Shepparton North-East Growth Corridor Development

Addendum to
Traffic Impact Assessment Report

Greater Shepparton City Council

Addendum Report B, Rev 2: 13/07/2018

Figure A1: Typical Road Profile for Road-01 – Connector Street Level 1 with Trunk Collector terminal

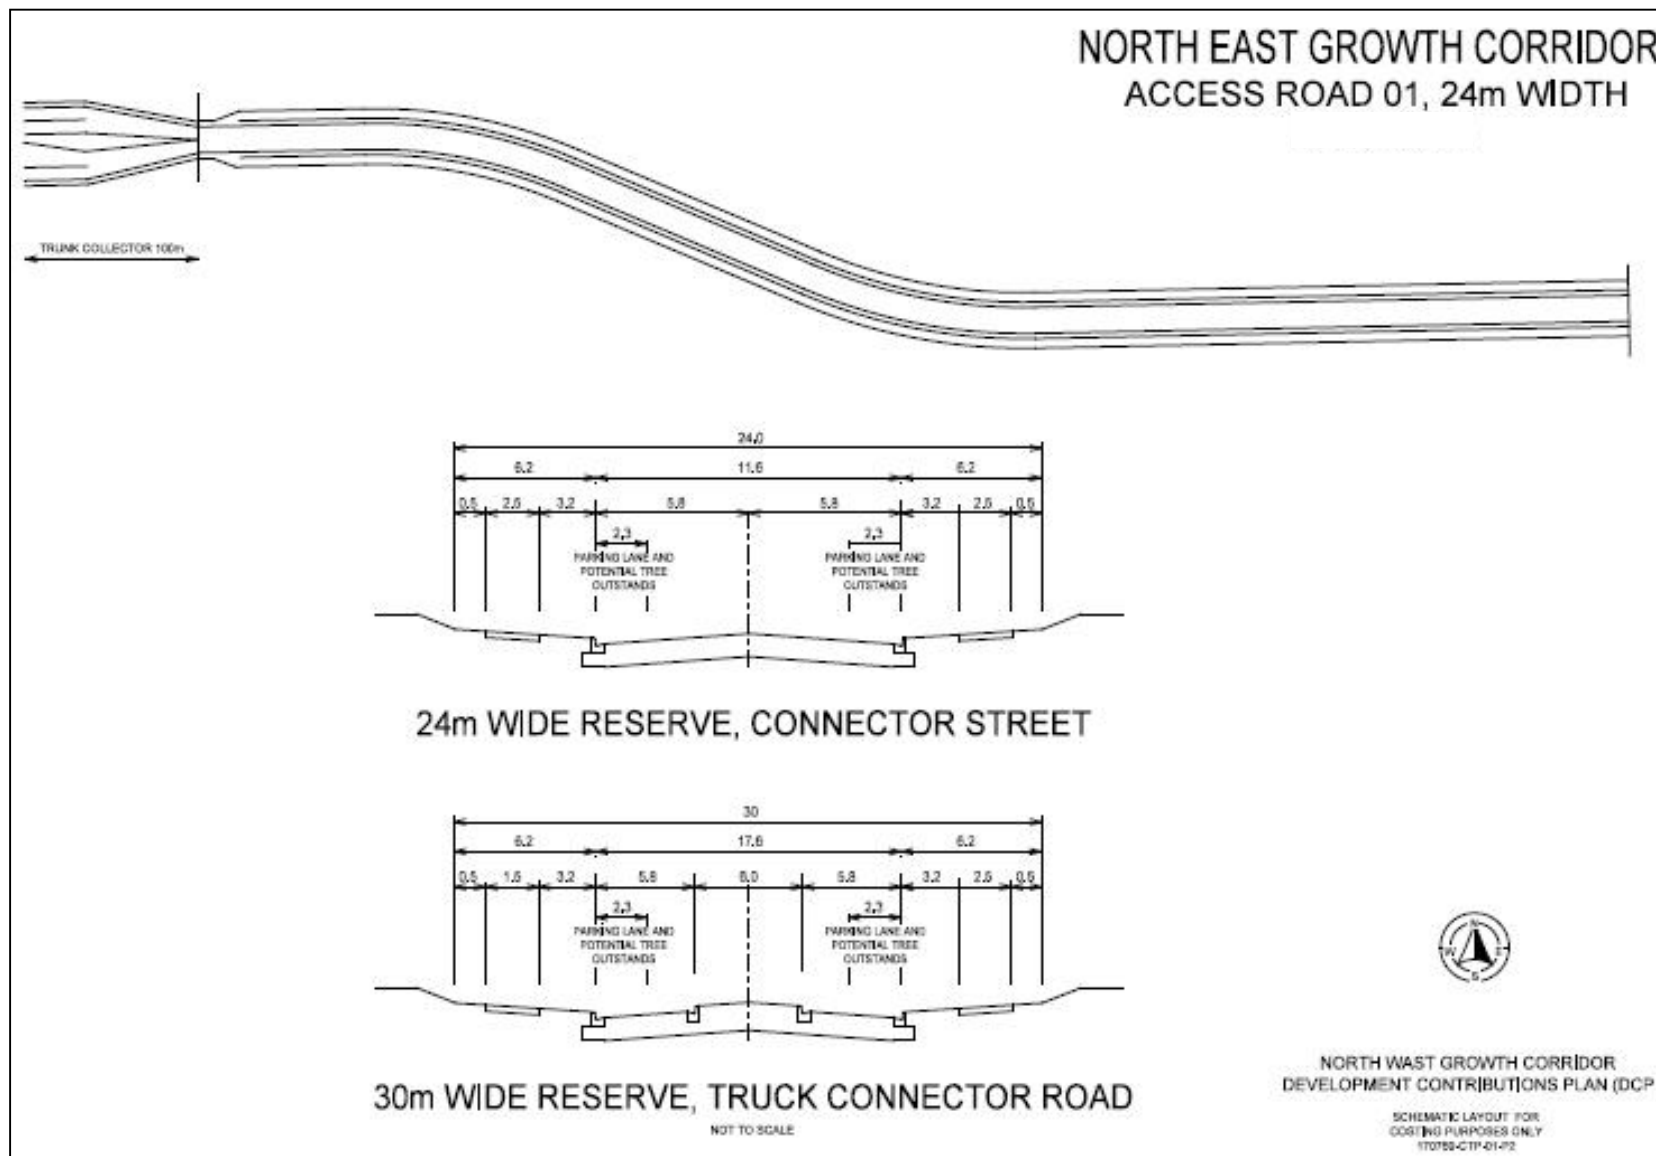
Road-01: Beyond the limits of the Trunk Collector Road for the first 100m from the signals at Verney Road to east of the community hub, Section 3.2 above indicates an ultimate requirement for a Connector Level 1 (24m) profile for this road to its junction with Road-03/Road-04. This configuration is outlined in the functional plan on page 37 of the DCP, but with the width reduced to 24.0m (refer to Figure A1 of Attachment A) and is supported.

Figure A3: Typical Road Profile for Road-02 – Trunk Collector full length from Verney Road to roundabout

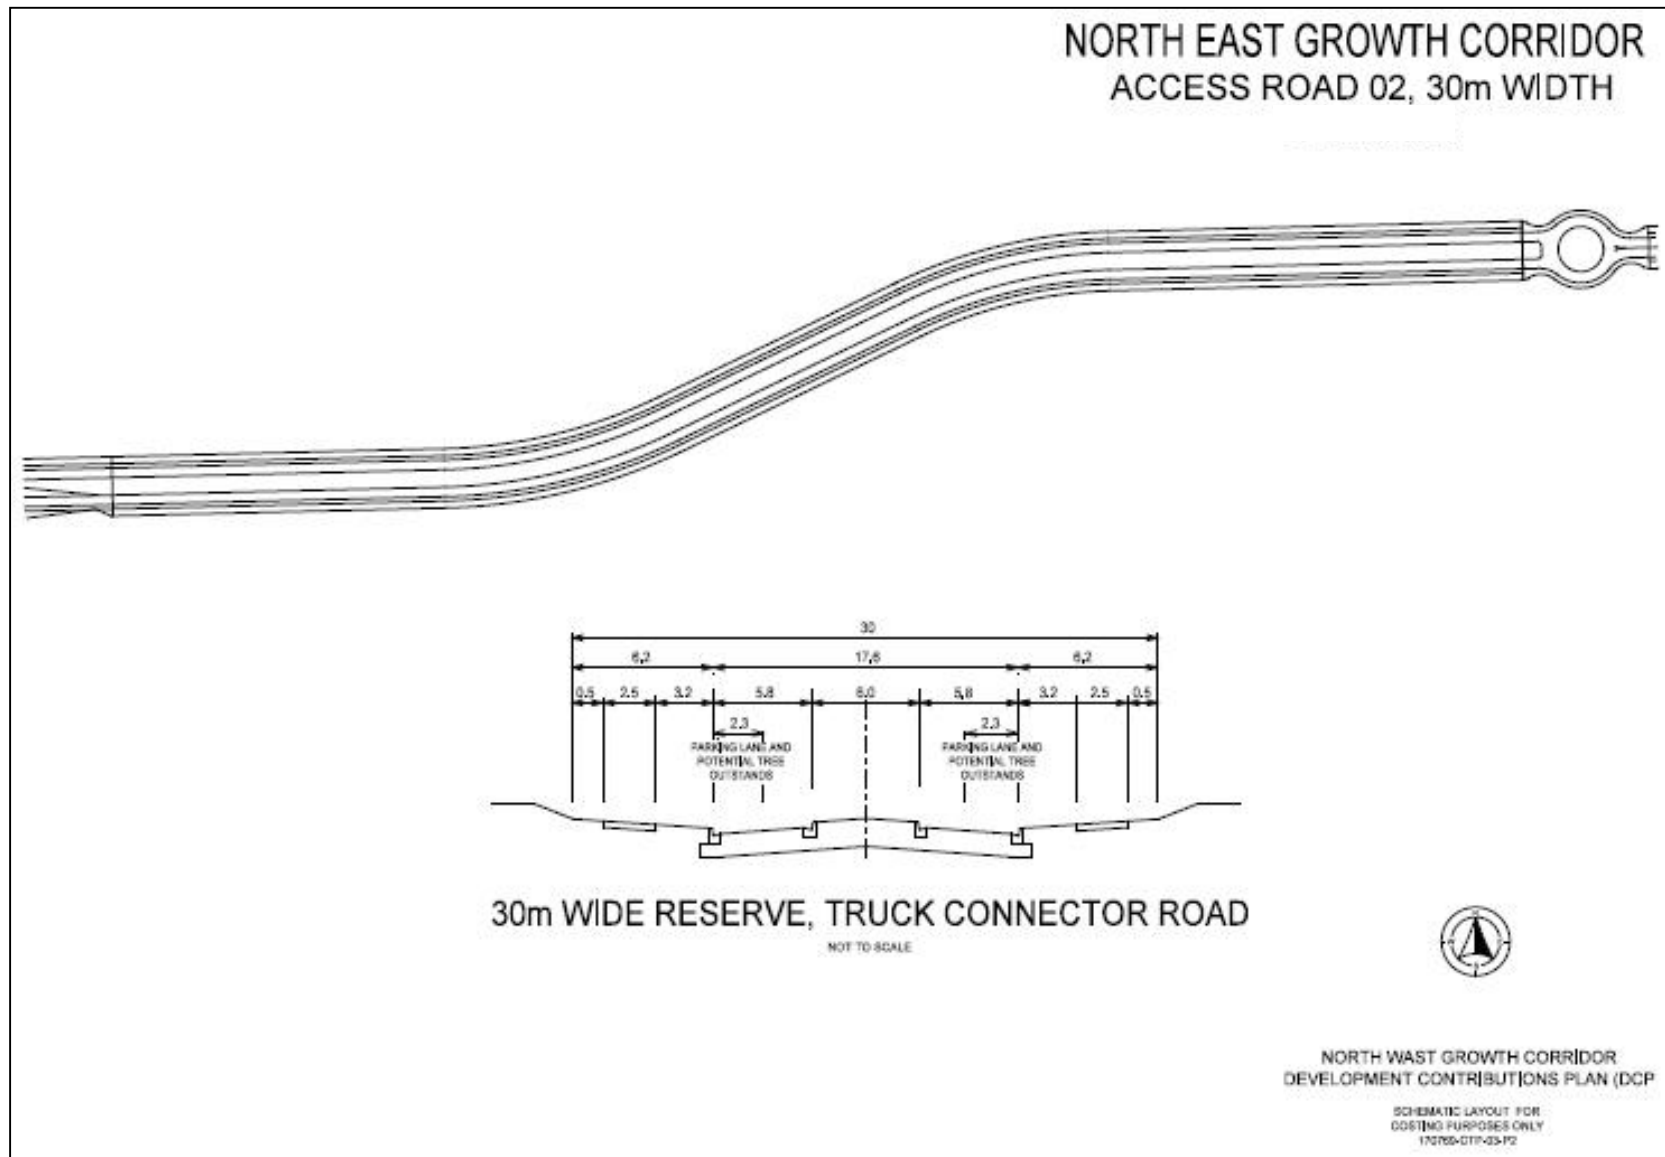
Road-02: Ultimate traffic volumes indicate a need for the full length of this road to be configured as a Trunk Collector Road as detailed in the functional plan on page 42 of the DCP but with the width reduced to 30.0m (refer to Figure A3 of Attachment A). It is noted that, if Access C is closed, the western 50m of the road is expected to experience traffic volumes in excess of the range for a Trunk Collector as set out in the IDM. It is considered that the IDM cross-section (34.0m) should be the minimum standard adopted for this road if closure of Access C proceeds to better accommodate mid-block traffic volumes. However, significant capacity issues would still exist at the intersection of Road-02 with Verney Road.

Figure A5: Typical Ultimate Road Profile for Road-03 – Connector Street Level 1 for full length

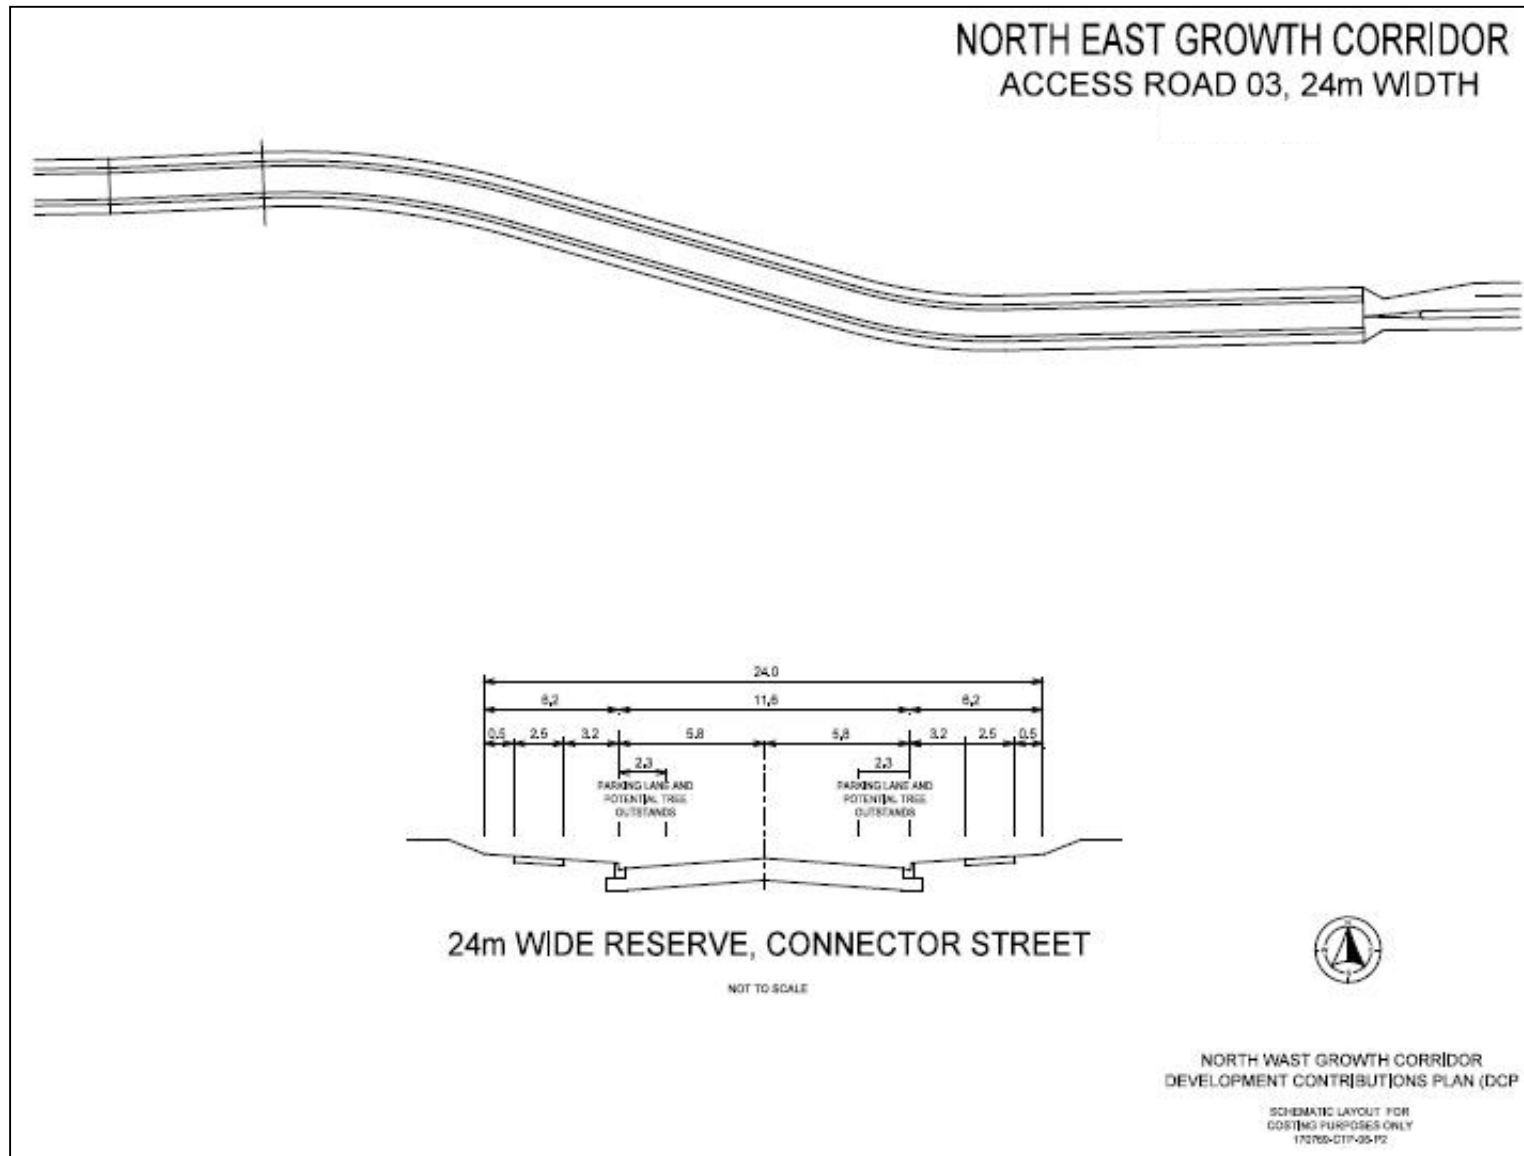
Road-03: Ultimate traffic volumes indicate a need for the full length of this road to be configured as a Connector Road Level 1 as detailed in the functional plan on page 39 of the DCP but with the width reduced to 24.0m (refer to Figure A5 of Attachment A).

Section 1
Access Street (16.0m)

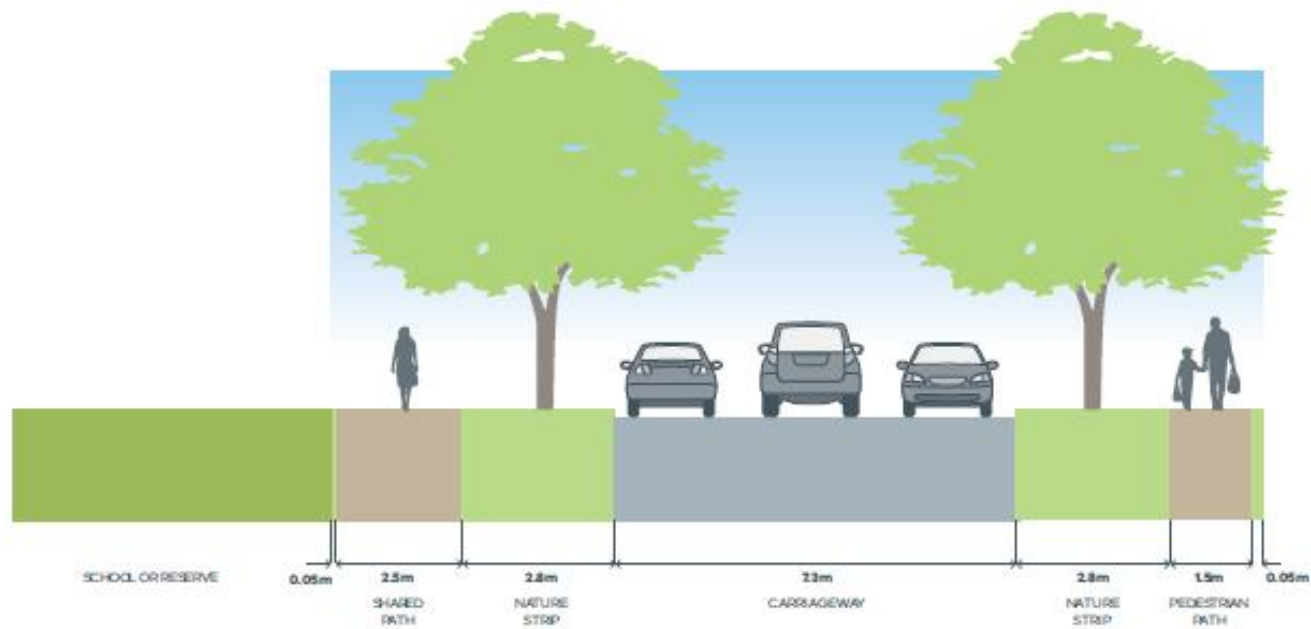
The updated cross-sections for Local Access Street (16.0m), Park and Retardation Basin Interface Street (16.0m) and Reserve and School Interface Street with shared path (17.0m) all provide a 7.3m carriageway width (consistent with Access Street in the IDM) and varying verge width configurations. Implementation of the strategy in Plan 5 of the PSP would result in the selection of the appropriate cross-sections that include shared path facilities along key cycling routes.

Section 5
Connector Street Level 1 (24.0m)

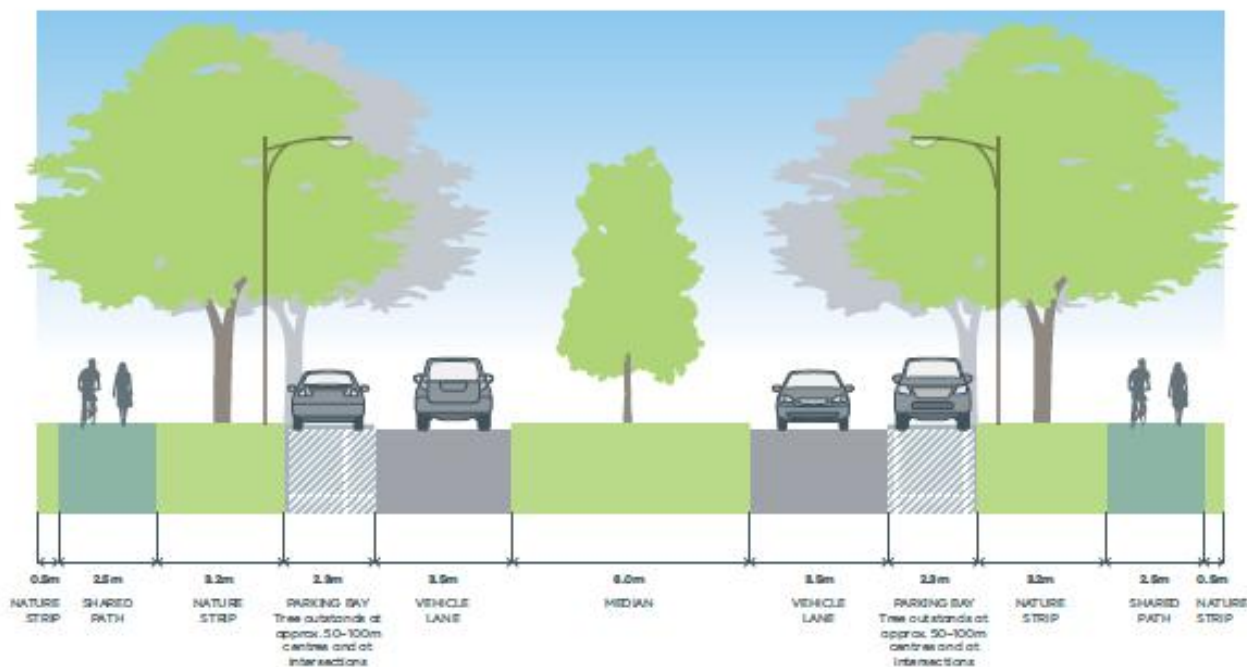
The modified cross-section for Connector Street Level 1 (24.0m) is consistent with the IDM Connector Street Level 1, and now provides an 11.6m wide carriageway with shared paths along both sides of the road. This cross-section is supported where applied to the appropriate traffic volume range.
